Illinois Tollway Base Sheet Revisions

Section M	Base Sheet Drawings	
	Drawing	Modification Summary Effective: 03-01-2018
	Roadway (RDY)-Series 400	
M-RDY-400	ROADWAY TYPICAL SECTIONS GROUP A	
	Change outside shoulder cross slope of 1% on SE left to "VARIES".	
	Inside shoulder width to "Varies" (Typ).	
	Inside shoulder cross slope to be 2% OR 4%. Outside shoulder cross slope to be 3% or 4%.	
	Lane 1 to be 12' (typ).	
	Added note for cross slope.	
	Removed % related to rollover max, added note to refer to RDC.	
	added max rollover note to SE right.	
M-RDY-401	ROADWAY TYPICAL SECTIONS GROUP B	
	Removed rollover in normal crown section.	
M-RDY-402	ROADWAY TYPICAL SECTIONS GROUP C	
	Delete sheet	
M-RDY-403	ROADWAY TYPICAL SECTIONS GROUP D	
	Added ground line to typical	
	Added "AGGREGATE SHOULDER" and "BREAKPOINT" callouts	
	Removed shoulder box	
	Added "SHELF"	
M-RDY-404	ROADWAY TYPICAL SECTIONS GROUP E	
	Added drainage criteria to min depth	
	Used same table shown in RDC Figure 2.6.8

ROADWAY TYPICAL SECTIONS
GROUP F

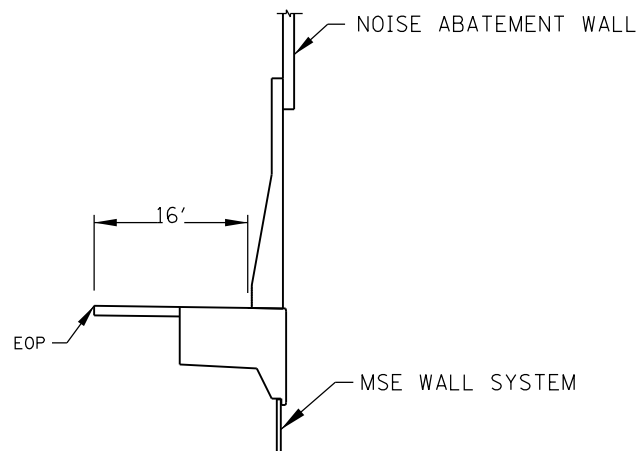
Inserted note 7 refering to drainage manual.	
M-RDY-405	ROADWAY TYPICAL SECTIONS GROUP F	
	Removed snow storage details	
	Added new snow storage details with retaining wall	
M-RDY-406	ROADWAY TYPICAL SECTIONS GROUP G	
	Removed snow storage width behind G-2 and G-3 gutters.	
	Removed "Single face reinforced barrier w/non-crashworthy noise abatement wall.	
M-RDY-407	EARTHWORK SCHEDULE	
	Changed title to EARTHWORK AND GUARDRAIL SCHEDULE	
	Added sameple guardrail schedule	
M-RDY-408	APPROACH SLAB, MAINLINE SHEET 1	
	Updated general note 2.	
	Added note to desinger	
M-RDY-408	APPROACH SLAB, MAINLINE SHEET 3	
	Revised note to "CORK JOINT FILLER, PER LATEST IDOT BRIDGE BASE SHEET"	
	Revised note to "1/8" ALUMINUM JOINT (FULL HEIGHT)	
	Added note 7. "THE 1/8" ALUMINUM SHEET SHALL BE ASTM B 209 ALLOY 3003-H14 AND COATED TO MINIMIZE REATION WITH WET CONCRETE"	
M-RDY-408	APPROACH SLAB, MAINLINE SHEET 5	
	Added detail from Tollway base sheets M-BRG-500 AND 501

ROADWAY SUBGRADE SLOPES
MEDIAN BARRIER

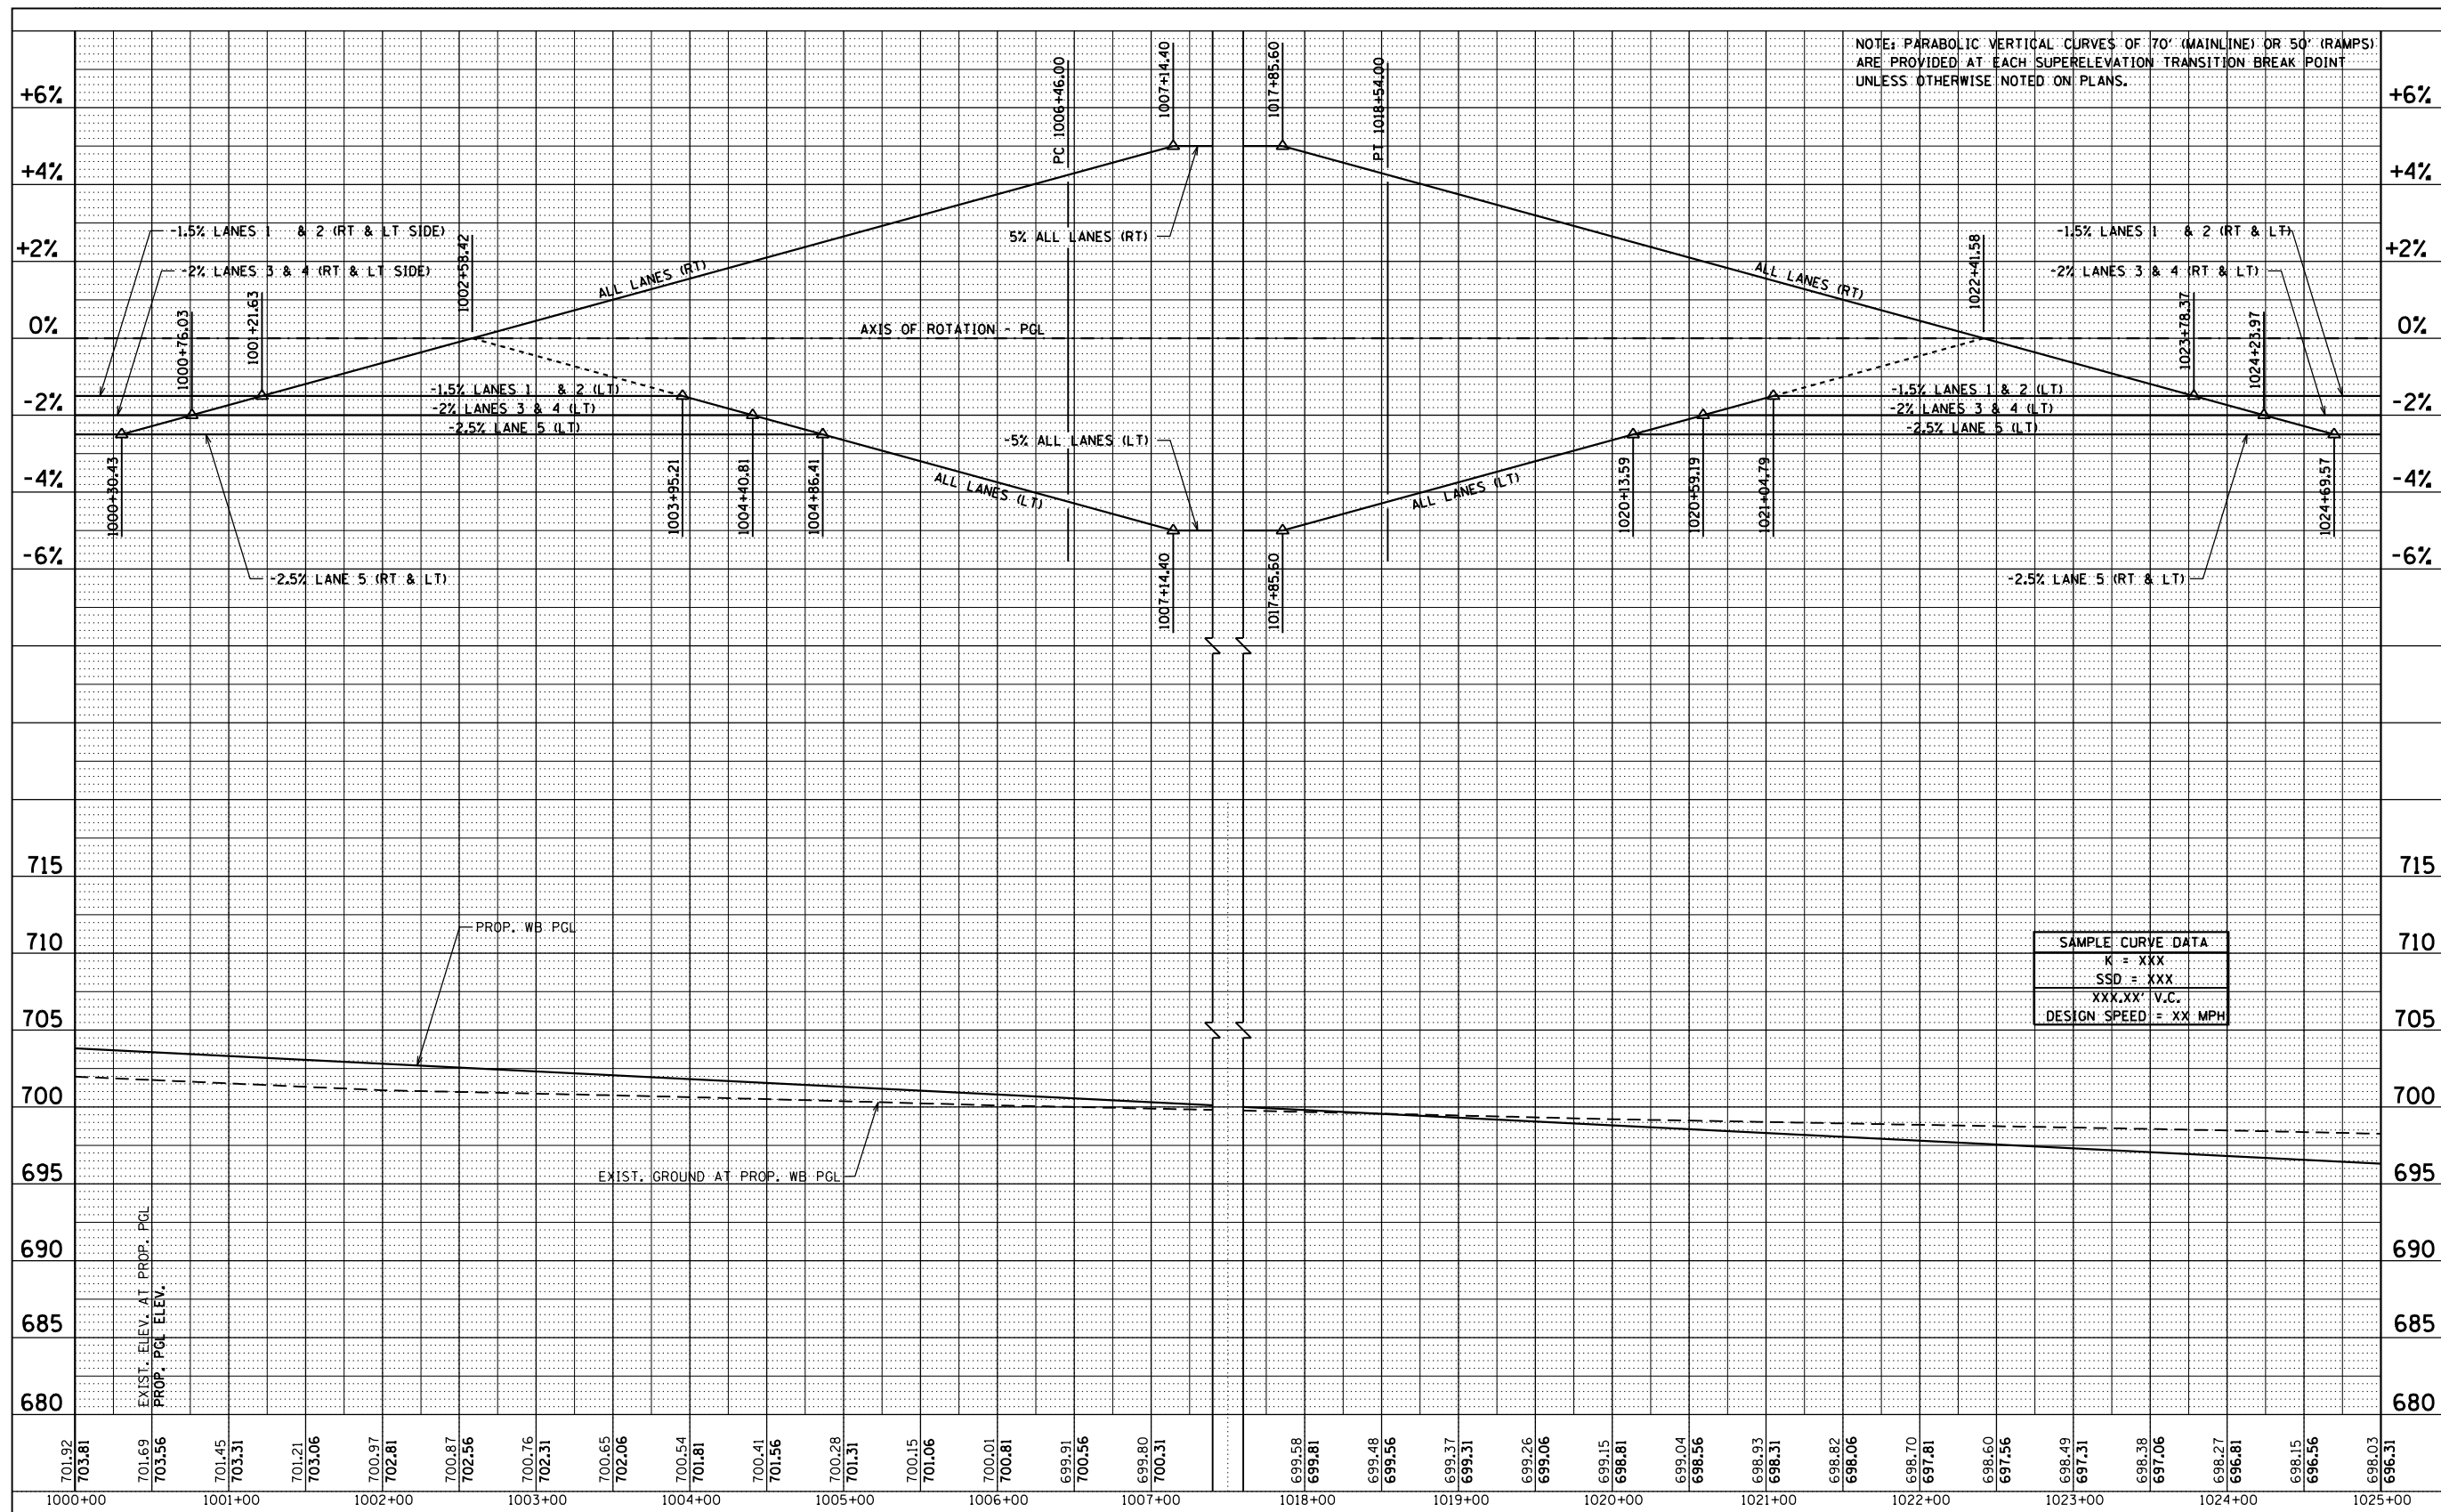
M-RDY-409	APPROACH SLAB, MAINLINE SHEET 1	
	Updated general note 2.	
	Added note to desinger	
M-RDY-409	APPROACH SLAB, MAINLINE SHEET 3	
	Revised note to "CORK JOINT FILLER, PER LATEST IDOT BRIDGE BASE SHEET"	
	Revised note to "1/8" ALUMINUM JOINT (FULL HEIGHT)	
	Added note 7. "THE 1/8" ALUMINUM SHEET SHALL BE ASTM B 209 ALLOY 3003-H14 AND COATED TO MINIMIZE REATION WITH WET CONCRETE"	
M-RDY-409	APPROACH SLAB, MAINLINE SHEET 5	
	Added detail from Tollway base sheets M-BRG-500 AND 501	
M-RDY-412	ROADWAY SUBGRADE SLOPES MEDIAN BARRIER	
	Add 3.5% max. rollover for flex lane section	
	Should be S.E. instead of 2% for subgrade slope on the low side	
	Should be 1.5% min. instead of 2% for subgrade slope on the high side (to match note 9 of standard B24-05)	
	Add 4.0% as the inside shoulder cross slope for non-flex lane in tangent section.	
M-RDY-414	ROADWAY PROFILE & SUPERELEVATION	
	Added new profile and super sheet.
